COMMENTS – CORRECTED VERSION 2.0

Environmental Scoping Report

The First Polish Nuclear Power Plant

Ir. Jan Haverkamp

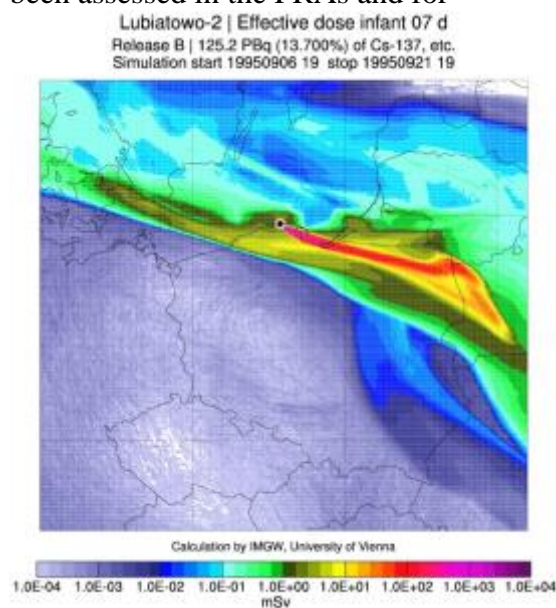
51. The Zarnowiec site should be investigated for its importance for breeding birds in the ruins of the old nuclear power station as well as feeding area for protected bird species.
